## STAFF RECOMMENDATION

1014 Petway Avenue

August 15, 2018

**Application:** New Construction—Addition; Partial Demolition

**E-1**

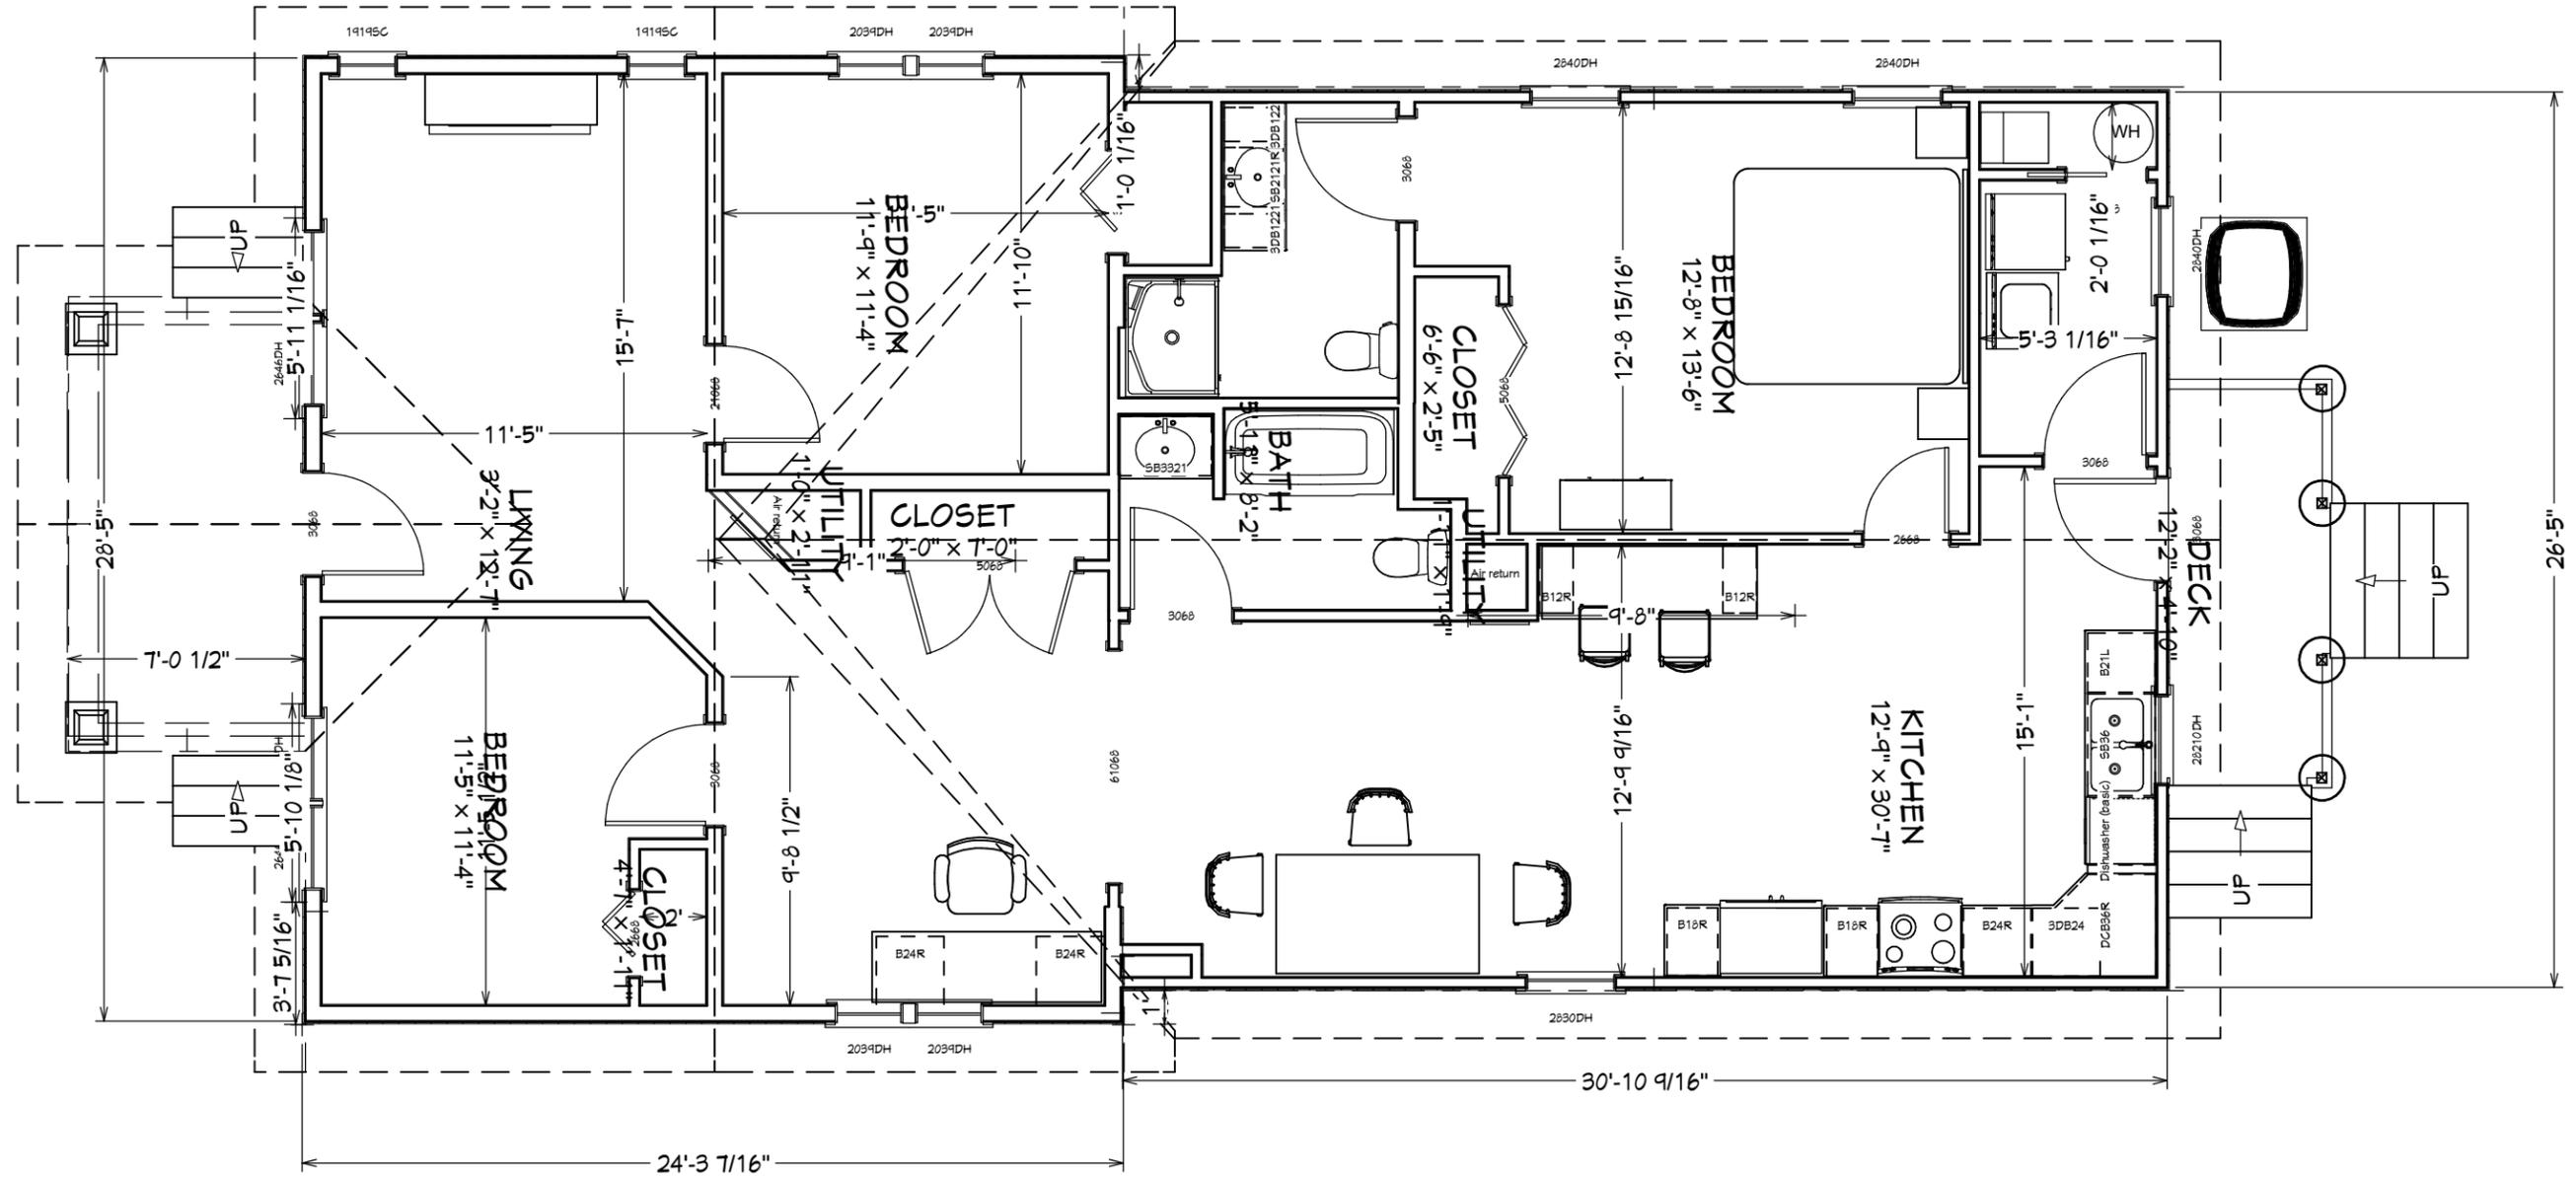
The plans do not show corner-boards at the face of each exposed corner. Four inch (4”) nominal corner-boards must be shown on the elevations since the addition is non-masonry. With the condition that the elevations incorporate corner-boards and the condition that staff approve the materials for the windows, door, trim, and roofing color prior to purchase and installation, staff finds that the project can meet Section II.B.1.d.

Roof form: The addition has a gabled roof form with 8/12 pitch that will tie into the existing roof approximately nine inches (9”) below the ridge. Staff finds that the proposed roof form is compatible with the existing house, and meets Section II.B.1.e.

Appurtenances & Utilities: No changes to the site’s appurtenances were indicated on the drawings. The location of the HVAC and other utilities was also not noted. Staff asks that the HVAC be located on the rear façade, or on a side façade beyond the midpoint of the house. The project meets section II.B.1. i.

1. Staff approve the windows, door, trim, and roofing color prior to purchase and installation;
2. For non-masonry buildings, 4 inches (nominal) wood corner-boards are required at the face of each exposed corner; and
3. The HVAC shall be located behind the house or on either side, beyond the midpoint of the house.
